Agenda
Planning Commission Meeting
Wednesday, January 27, 2016
City Hall Council Chamber | 505 Swift Boulevard

Request: Deviate from Central Business District Building Standards

STAFF REPORT

REQUEST: APPROVAL OF A REQUESTED DEVIATION FROM CENTRAL BUSINESS DISTRICT DESIGN STANDARDS, AUTHORIZING THE PLACEMENT OF A BUILDING IN EXCESS OF THE MAXIMUM FRONT YARD SETBACK REQUIREMENT.

SITE PLAN

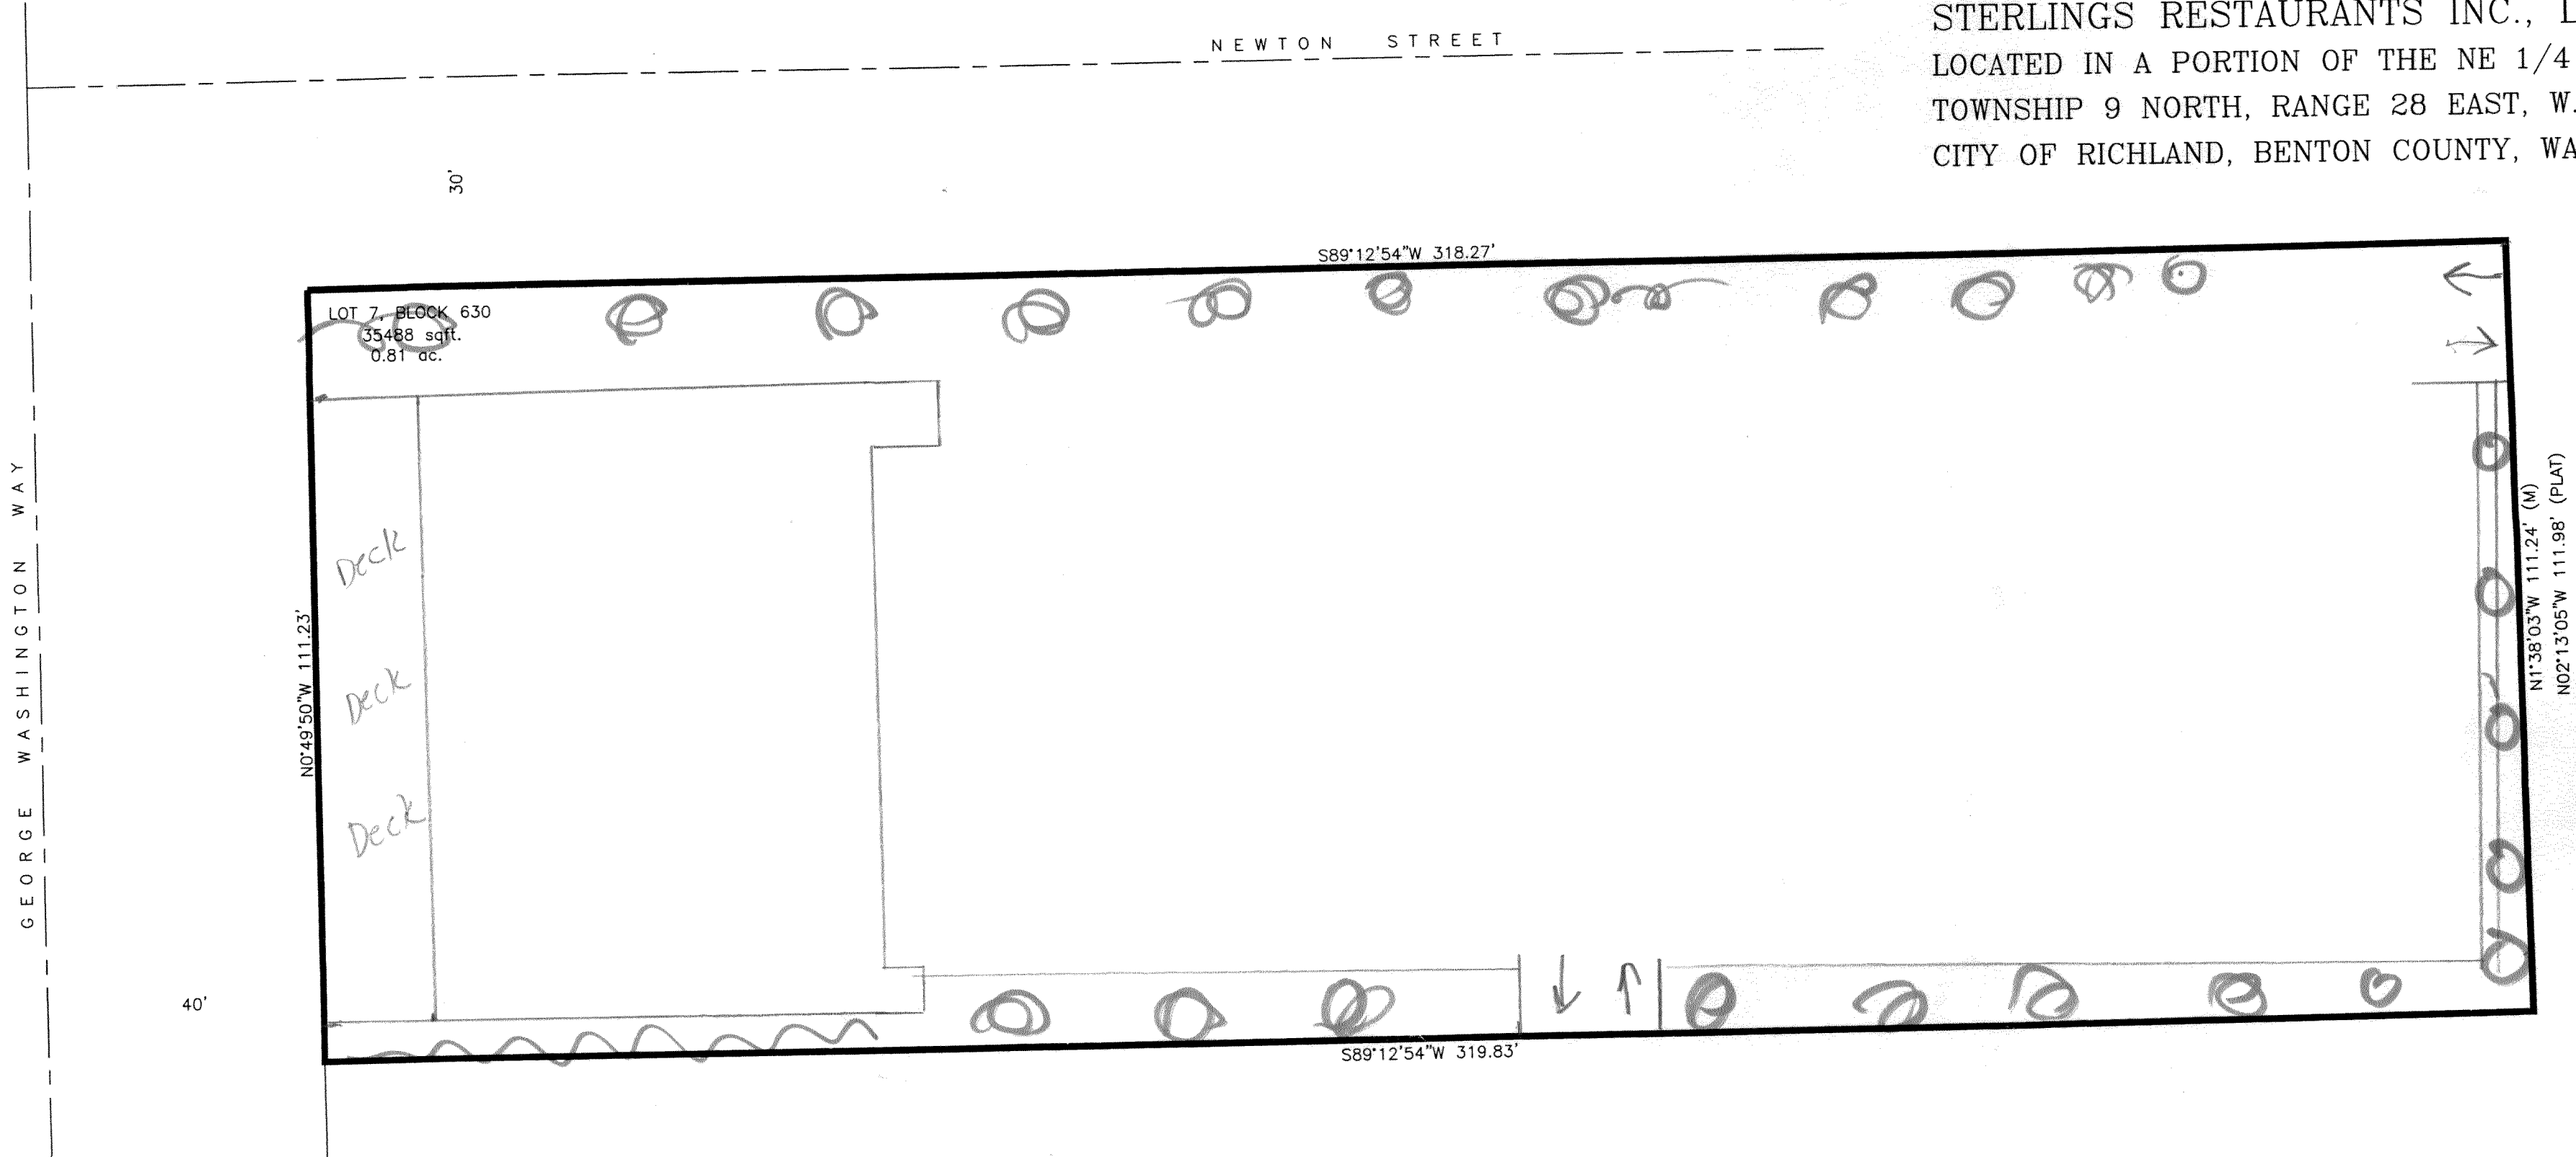
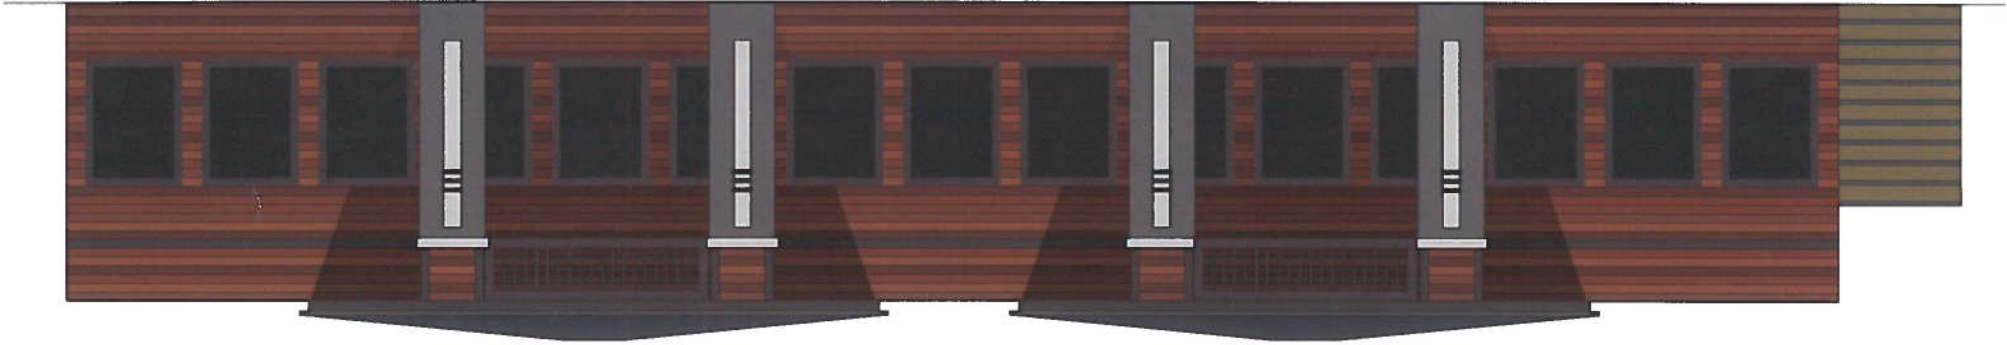
The building would be setback approximately 5 feet from the Newton Avenue right-of-way and approximately 230 feet from the George Washington right-of-way, making the building compliant with the Newton setback requirement but not the George Washington Way setback requirement.

1. The plans do not indicate how the maximum setback area (20 feet) would be addressed, other than to note generally that landscaping would be provided along both the George Washington Way and Newton Street frontages.

2. a. Glass fenestration along the Newton Street frontage is approximately 35%, and so does not meet the standard of 50 – 80%. On the George Washington Way side of the building, fenestration is less than 20%. On the east side of the building, facing the park, glass fenestration is approximately 70%.

8. The plans submitted to the City are not detailed enough to determine location of refuse dumpsters etc.

The applicant's plans do not meet the City's design standards concerning the setback of the building from the George Washington Way frontage. The plans are also inconsistent with the requirement for a minimum of 50% fenestration on the street side of the building, although this standard is met on the site of the building facing the park.

1. The maximum setback area (20 feet) along the George Washington Way frontage shall be developed with landscaping, street furniture, sidewalks and a low masonry wall;
2. The applicant shall submit a detailed landscaping plan to the City for review and approval. Said plan shall use the same types of planting materials and landscape treatments utilized in the adjacent Newton Street landscape strip.
3. A low masonry wall, no more than three feet in height shall be constructed along the site's George Washington Way frontage to aid in reducing the visual impact of the off-street parking area as viewed from the George Washington Way corridor.
4. All landscape improvements shall be subject to review by the Public Works Department for compliance with City clear vision triangle requirements.
